Our Reference: 21_82_CPPL_EDCP_DD

Subject: 1111-1141 ELIZABETH DRIVE SUBDIVISION, CECIL PARK (SSD 8859) ACCESS REVISED DESIGN

Appendix A – Revised Access Design

FAIRFIELD CITY COUNCIL AREA
1111-1141 ELIZABETH DRIVE
CECIL PARK, NSW 2178
LEFT-IN LEFT-OUT ULTIMATE TNSW DESIGN
DEVELOPMENT ACCESS
GENERAL ARRANGEMENT PLAN

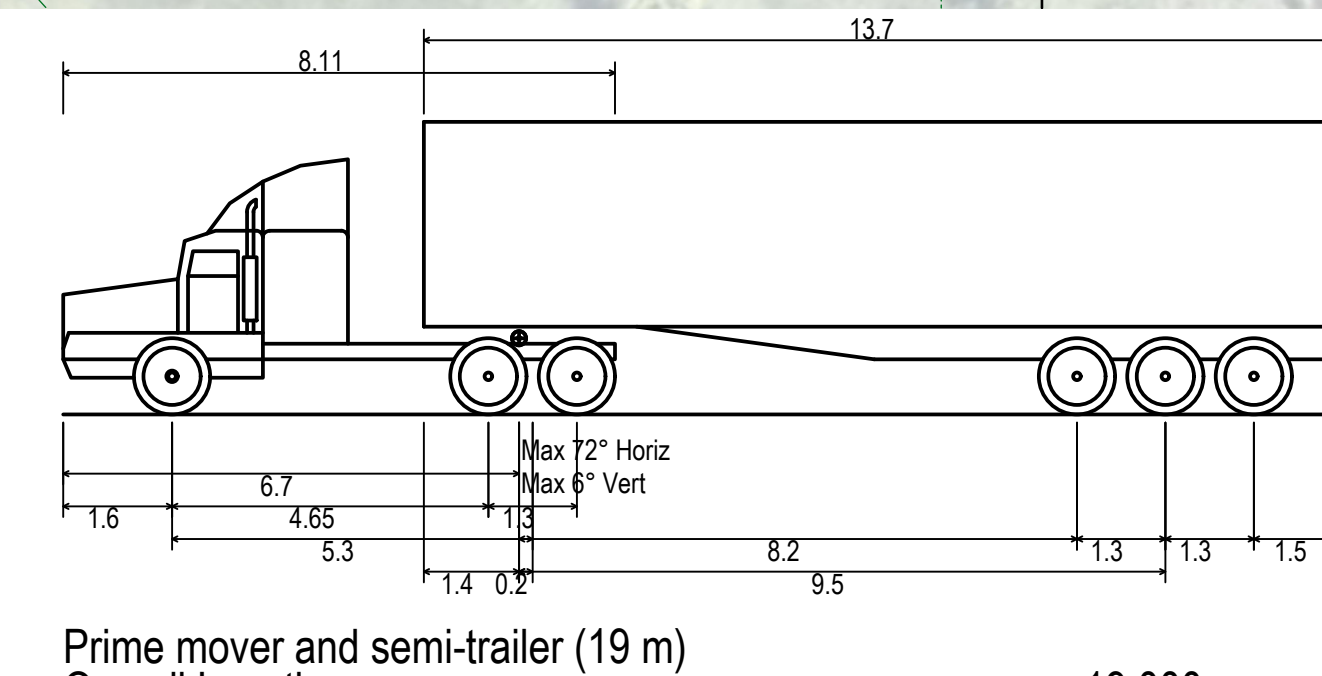
TfNSW Review Comments	MU Group Response
<p>1. There is a safety issue of the arrangement of the development of the second kerb side lane and the proposed left turn deceleration lane.</p> <p>Vehicles exiting the access road could confuse vehicles changing lanes to access the second kerb side lane with vehicles wanting to access the left turn deceleration lane and could lead to accidents. TfNSW requests that the development of the second lane be moved further back to the north in Wallgrove Road to the short straight between the reverse curves. The diverge should initiate from the centreline so vehicle continuing in the original lane is in lane one. The second lane should be fully developed prior to the second curve.</p> <p>The proponent should consult with M12 project team regarding the above for the best way forward.</p>	<p>TfNSW agreed that this is outside our limit of work. The development is constrained by the extent of the property boundary.</p> <p>It was agreed with TfNSW that this will be accommodated by the M12 project team.</p>

<p>2. The length of the left turn deceleration lanes is too short for the design speed of Wallgrove Road. The design speed of Wallgrove as per design criteria for this section of Wallgrove Road is 70kph with a posted speed of 60kph. For a design speed of 70kph the length should be 70m (including taper) with a turn speed of 20kph.</p> <p>As there is no development in the adjacent property and will be kept within the road reserve the length should be increased to be complying for the design speed.</p>	<p>The deceleration lane has a design length of 60m. It is noted that Austroads, Part 4a, Section 5.2 Deceleration Lanes, requires a deceleration lane length of 60m based on design speed of 70km/h and exit speed of 30km/h.</p> <p>The exit speed of 30km/h was adopted as the design has allowed for a left turn radius of 20m, which equates to an exit speed of 30km/h as per Austroads Table 5.2 and Figure 5.2.</p> <p>TfNSW indicated that this approach is acceptable based on the constraints and posted speed of 60kph.</p>

<p>3. Assuming that a second lane will be introduced prior to the auxiliary lane, the proponent will need to demonstrate that appropriate sight distances (AUSTROADS) are achieved to the C1 line.</p> <p>A preliminary review of the design suggests this to be problematic. Note the design will be providing a G4 W Beam to protect the 2:1 batter. Given the downgrade on approach, the sight distance over the barrier may be achieved but this would need to be checked. To achieve compliance the length of auxiliary lane will need to be extended, else the verge and batter widened out which may result in works occurring outside of the project boundary.</p>	<p>The sight distance assessment achieves a clear sight distance of 145m measured</p> <p>It is noted that Austroads Table 3.2 indicates a SISD of 141m for a reaction time, Rt, of 1.5 sec (the Rt satisfies the TfNSW supplement to Austroads Part 3). The assessment is also based on a driver height and observed height of 1.1m and 1.25m respectively, whilst the barrier height is expected to be at approx. 0.9m. The location of the barrier is yet to be confirmed through a 3D design model.</p>

TfNSW agreed that this will not affect the development and can be addressed in the detailed design phase.
4. The addition of the auxiliary lane will mean additional cutting into existing area which may compromise flood immunity. There is channel at the toe of the embankment. Widening out the carriageway for the auxiliary slip lane will mean that additional property acquisitions may be required as the earthworks associated with the channel will be outside of the project boundary. The same applies to the channel running further to the north- given the need to widen the carriageway to allow for the development of the second lane.	<p>The submitted design is a strategic 2D layout only, and has not incorporated any survey. Given the 'green field' nature of the site, TfNSW may provide a design level for the development to adhere to for flooding and drainage designs as part of the development consent.</p> <p>TfNSW agreed that a 2D layout drawing is sufficient for the development application. A 3D assessment can be undertaken in the detailed design phase..</p>

6. The plan should be amended to remove all the chevrons in the entry and exit as it will get scrubbed out and it also entices pedestrians/cyclists to stand in the actual access.	The chevrons have been removed in the revised design. Further refinement of the line marking can be addressed in the detailed design phase.

7. The "No Access to Cecil Road" signs should be removed as it would be difficult to enforce.	The signposting has been removed in the revised design. The OTAMP can be conditioned for the development to develop prior to operation.
An Operational Transport and Access Management Plan (OTAMP) should be developed for the proposed subdivision to manage this arrangement.	TfNSW agreed that further adjustments to signposting can be addressed in the detailed design phase.

8. It is not clear why turning path has been provided for a B-triple (35.4m). NSW Freight and Ports Plan used 30m Performance Based Standards (PBS 2B) combinations as the target vehicles. The use of the B-triple requires the access to be wider than needed and lengthens the crossing distance for active transport users. As previously advised, PBS 30m vehicle should be used as checking vehicle.	<p>For consistency with previous correspondences with TfNSW in May 2021 a similar 35m B-Triple was used as check vehicle on the access design.</p> <p>However, as agreed with TfNSW, a 19m semi has been used as design vehicle and 26m B-Double as check vehicle. These are reflected in the revised design.</p>

9. The proponent is requested to update the plans and annotate with some dimensions; lane widths, path width. Information on the RT bay and whether it is of sufficient length should be confirmed.	<p>Lane widths and path widths have been provided as shown in the revised drawings.</p> <p>Note that the lane widths were adopted from the TfNSW Wallgrove Rd design. Also, note that there is</p>

no RT bay for the development as previously agreed with TfNSW.
10. The design shows the continuation of a shared user path past the intersection of the DA site. The current intent is not to continue this further to the North. The shared user path connects the Cecil Rd crossing along Wallgrove Rd to the south, integrating in with the shared user path on Elizabeth Drive.	<p>TfNSW advised to remove the shared path north of the intersection including the associated kerb ramps and gap in the median.</p> <p>TfNSW also advised to show connection of the shared path from the proposed Cecil Road into the development. The shared path along Wallgrove Road will be as per required width, whilst the connecting path into the development can be narrower.</p> <p>These have been reflected in the revised design.</p>

REV	AMENDMENT / REVISION DESCRIPTION	Initials	DATE
A	PRELIMINARY DRAWING FOR DISCUSSION	S.B.	11/11/2021
B	REVISED ENTRANCE AND EXIT LAYOUT DRAWING	S.B.	27/01/2022
